Paycor Stadium Upper Bowl Waterproofing Project
Bid Package 1: Waterproofing
ITB#058-26
Addendum 2

August 20, 2026

**Canopy Level Seating
Concrete &
Waterproofing
Repairs**

9
5.01 NO SCALE

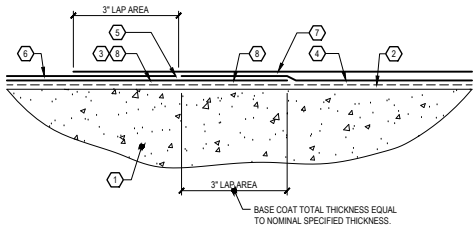
- Detail 9/5.01, Note 10 revised

- ONCE EXTENTS OF POORLY DRAINING AREA ARE IDENTIFIED, PREPARE SURFACES AND PROVIDE NEATLY BUILT-UP EPOXY/SAND MORTAR LEVELING COURSE TO PROMOTE POSITIVE FLOW TO DRAIN UP TO 1/2" AT LOCATIONS GREATER THAN 1/2". NOTIFY ENGINEER AND REPAIR PER DETAIL 4.01. REFER TO SPECIFICATION SECTION 030100. ENSURE THAT NEW LEVELING DOES NOT INADVERTENTLY CREATE ADDITIONAL PONDING AT ADJACENT SURFACES.
